Subject: AP1000 COL Response to Request for Additional Information (TR 85)

AP1000 TECHNICAL REPORT REVIEW

RAI Response Number: RAI-TR85-SEB1-40

Figure 3.4-4

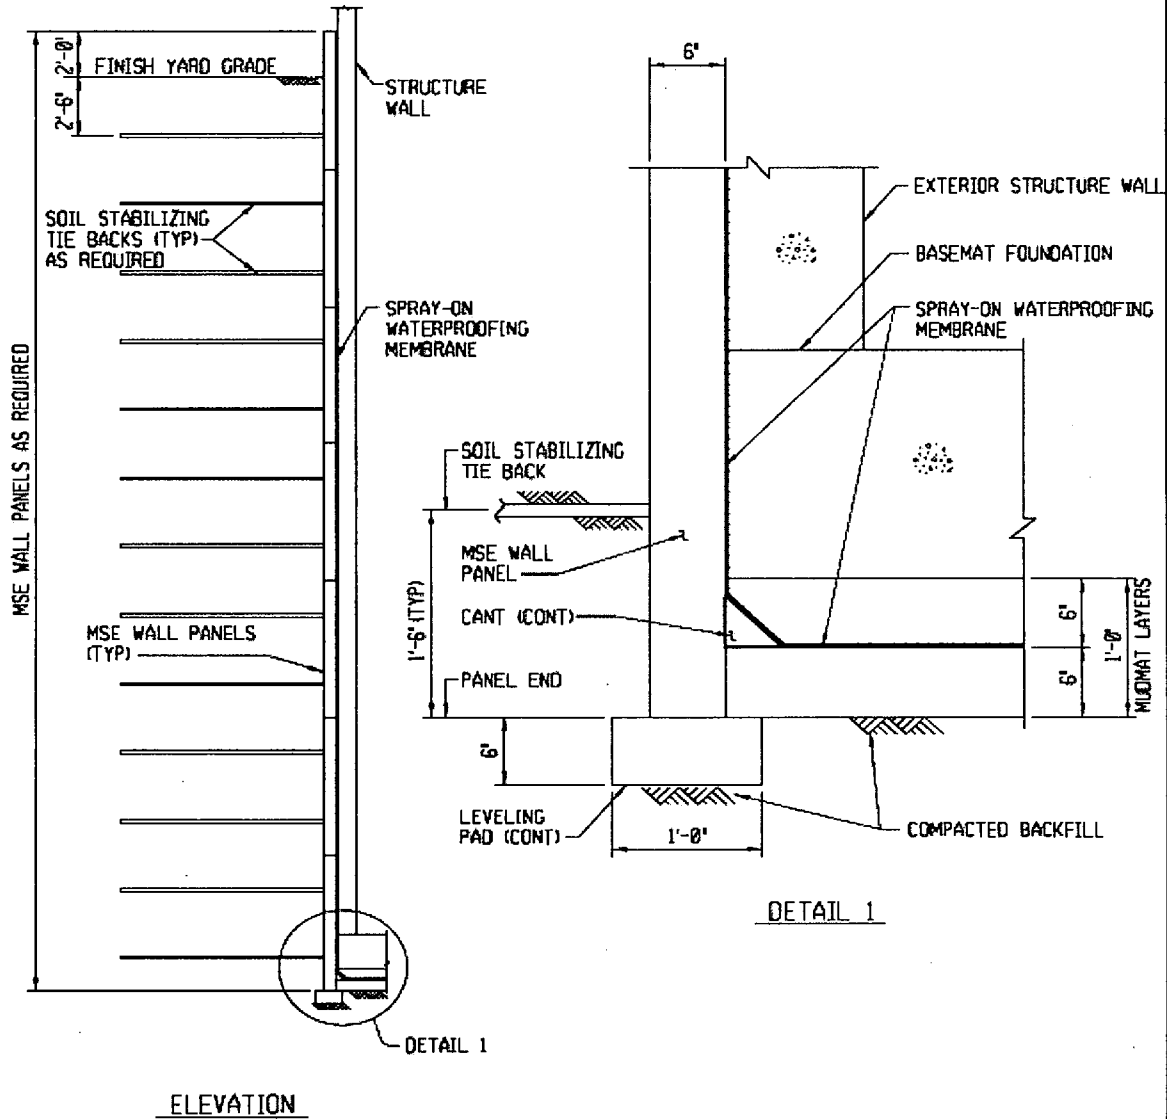
Regarding the dynamic stability of the NI structures, Westinghouse is requested to provide additional information to demonstrate how the sliding criteria assumed during the API000 SSI analyses (sliding friction value of 0.7) are in fact to be attained from the interface between the basemat and mudmat and from the interface between the top portion of the mudmat and the lower portion of the mudmat through the waterproofing membrane.

This method may be used for either soil sites, in conjunction with a mechanically-stabilized earth (MSE) wall, or for rock sites, where an open excavation may be used. Figure 3.4-4 shows the typical installation using MSE walls, with the sprayed-on waterproofing membrane placed on the MSE wall panels and between the two layers of the mudmat. Where the vertical face of excavation is used as a form for the exterior walls, the waterproof membrane is installed on the vertical face of the excavation prior to placement of concrete in the exterior walls.

The waterproof function of the membrane is not safety related; however, the membrane between the mudmats must transfer horizontal shear forces due to seismic (SSE) loading. This function is Seismic Category I. The specified static coefficient of friction between horizontal membrane and concrete is ≥ 0.7 . The waterproof membrane shall have physical properties, including surface and texture, to achieve the required static coefficient of friction. Primer, geotextile, or aggregate scatter may be added as required.

Add Figure 3.4-4 following Figure 3.4-3
